GRADING & EROSION CONTROL PLANS FOR
MURPHY USA (NTI)
EL PASO COUNTY, COLORADO
7825 MERIDIAN PARK DRIVE (MURPHY #7968)

GEC PLAN
MURPHY OIL USA #7968
PCD FILE #: PPR244

PHASE I (INITIAL)
PHASE II (INTERIM)
EROSION CONTROL PLAN

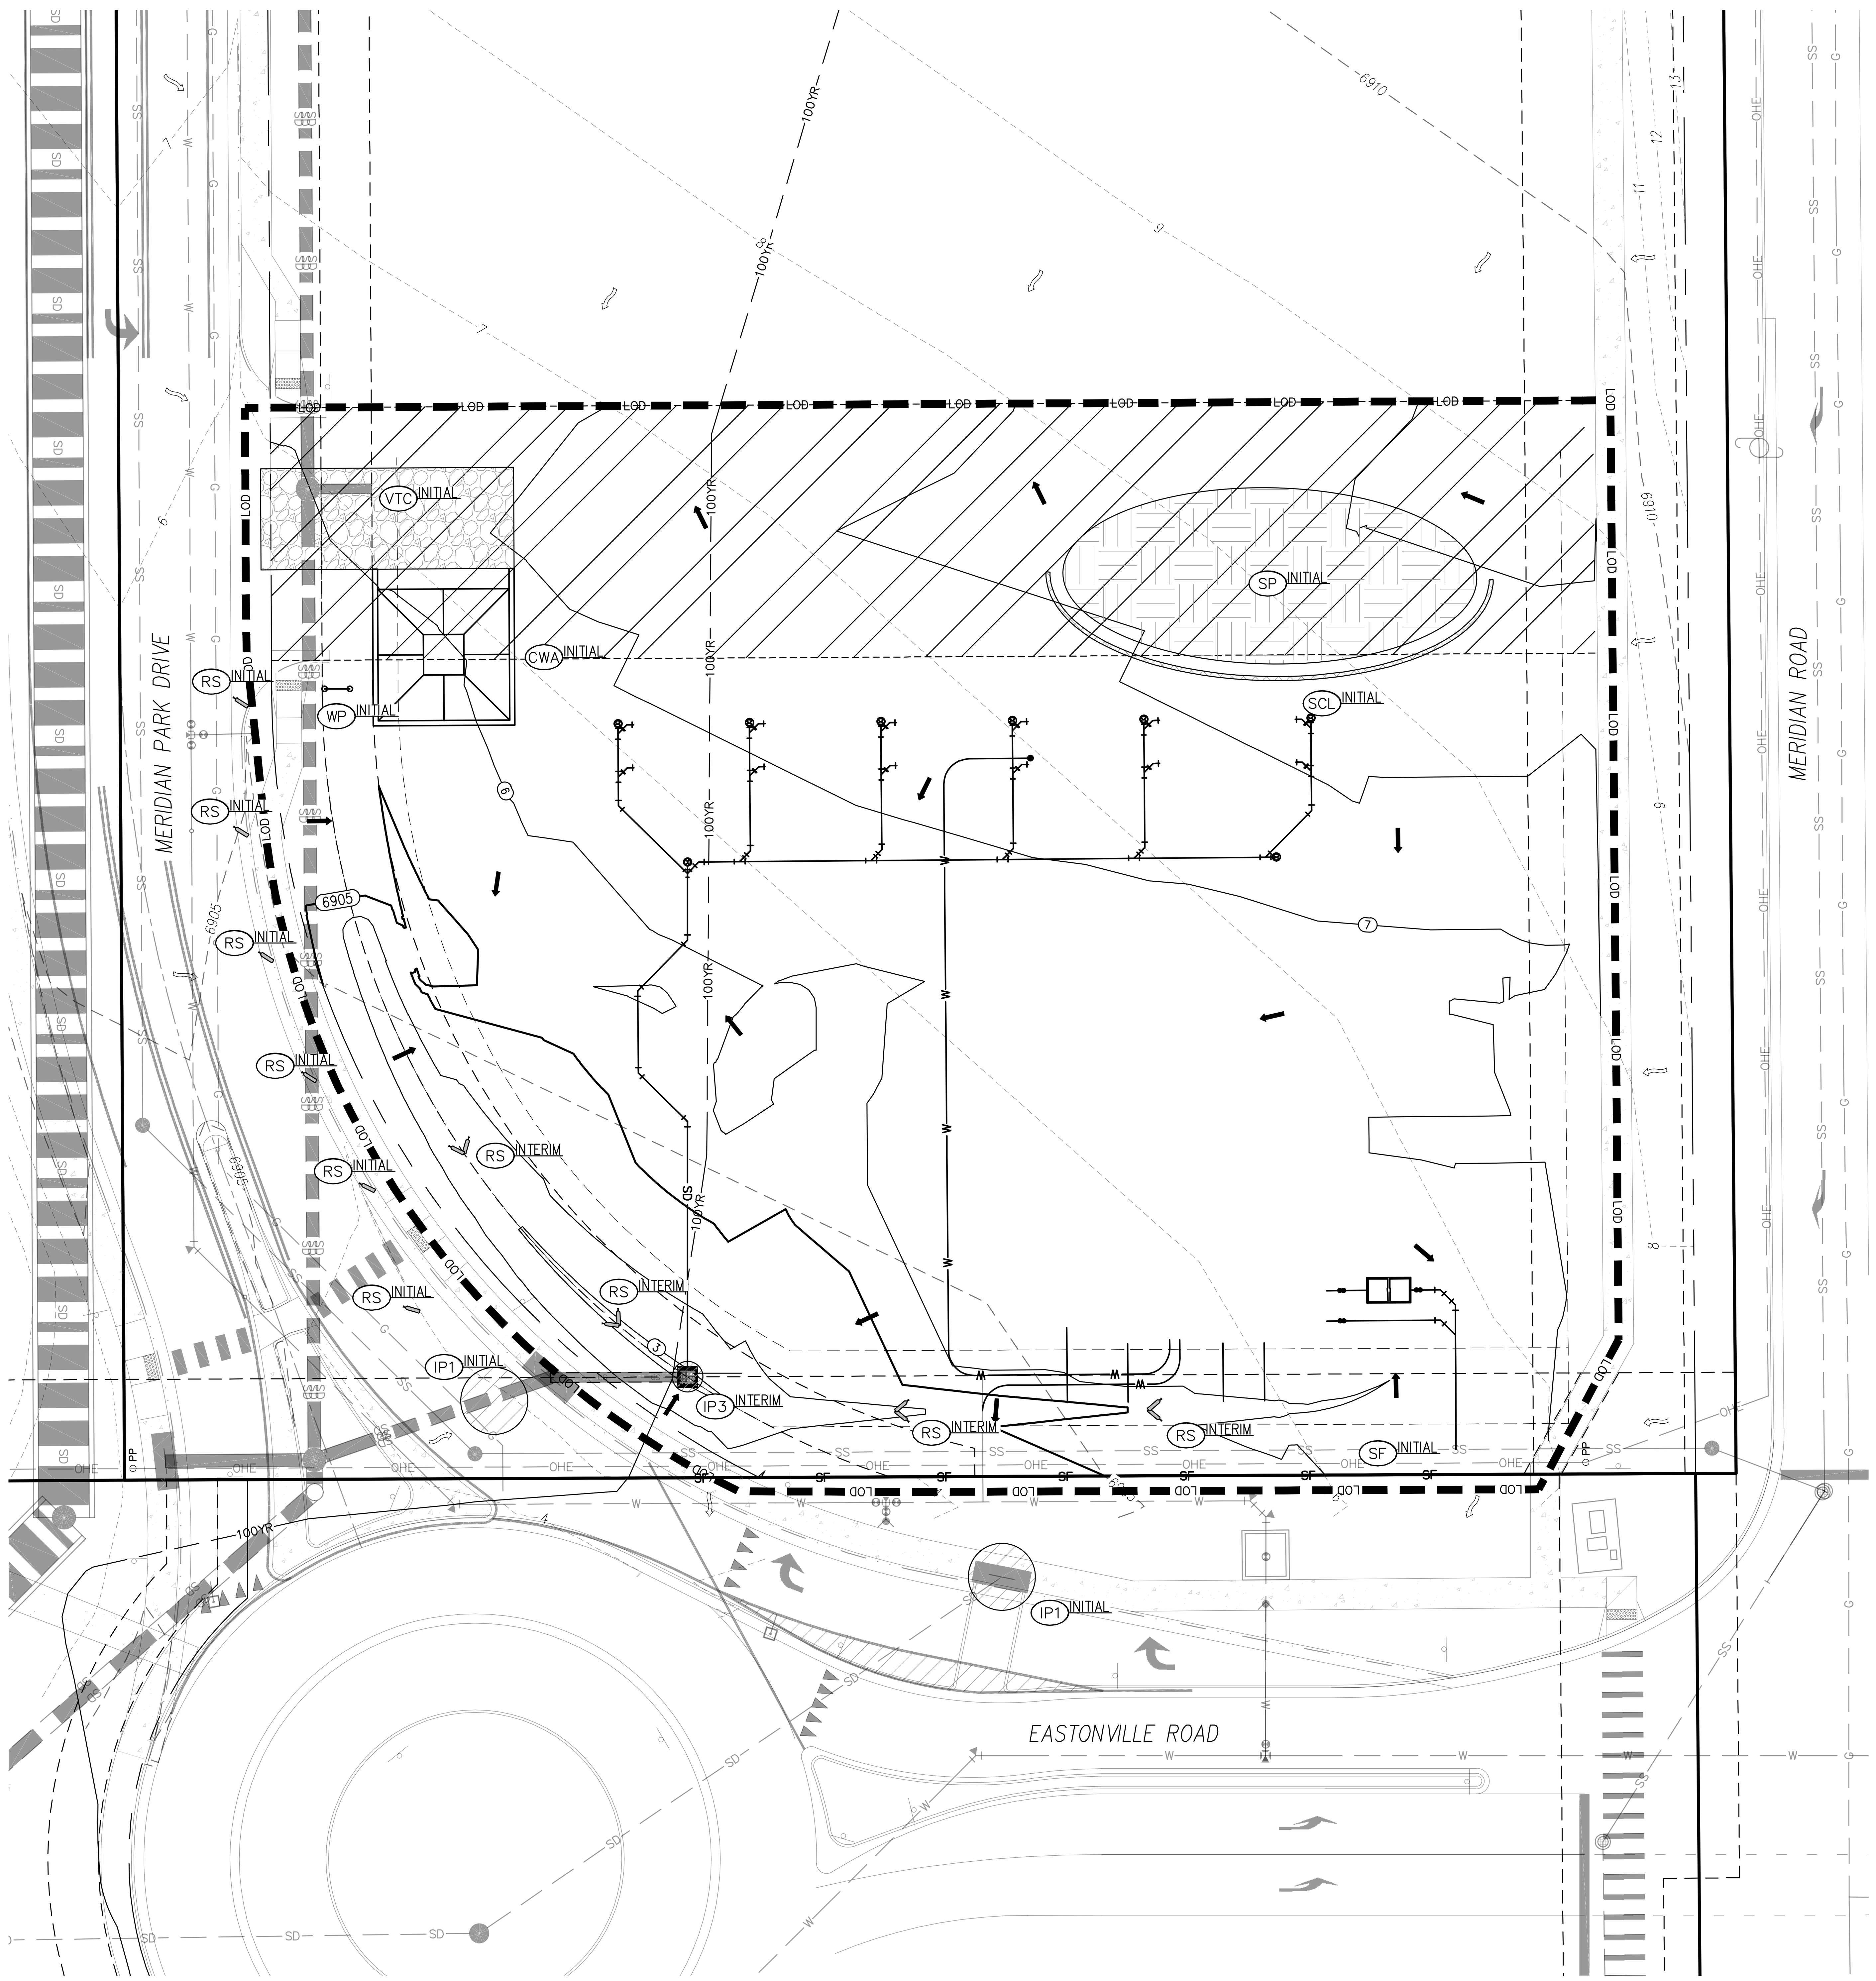
This current review is Review #5. With the Review #1 I had asked for onsite pre-treatment for hydrocarbons because this site drains directly to a pond that is currently County owned and is soon to be County maintained. So we have to protect our pond from hydrocarbons discharging from your site. Subsequently with Review #2, a water quality product (called a SNOUT) was added to the PCM Applicability Form and Final Drainage Report. But it was never added to the Financial Assurance Estimate (FAE) Form or these GEC Plans. A hydrocarbon absorbing product needs to be included at the inlet that leads to the County pond and included on all 4 of the aforementioned docs. This product will need to be considered an official PCM (and thus need a Maintenance Agreement) just to better protect our pond long-term.
